Tesla, Inc. Service Bulletin		<i>Replace Instrument Panel Carrier Due To Bumps Or Bubbling</i>	
SB-19-14-001 September 25, 2019			
Classification Repair Bulletin		Section/Group 14 - Instrument Panel & Pedals	Mobile Service Cannot Perform
Model Year 2017 - 2019	Model Model 3	Country/Region All	Version All
<small>The model(s) and model year(s) listed are a general approximation of the affected VIN list. Refer to the VIN/Bulletin Tracker or Customer/Vehicle profile to determine applicability of this bulletin for a particular vehicle.</small>

Figure 1

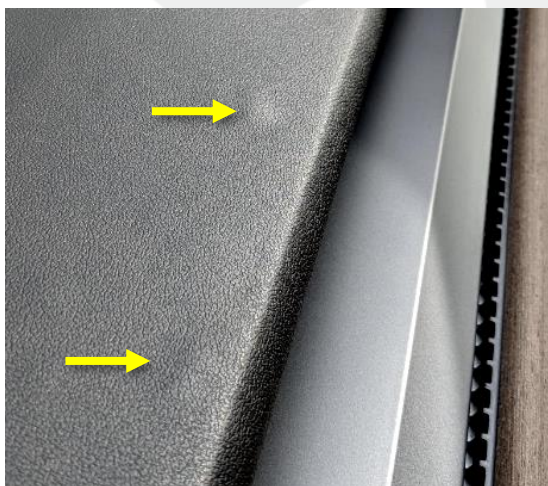
On some Model 3 vehicles, the top or front surfaces of the Instrument Panel (IP) carrier might form bubbles or bumps (Figures 1 and 2) in warm ambient temperatures.

Inspect the vehicle for symptoms related to the condition. If symptoms are present, replace the IP carrier with an updated component.
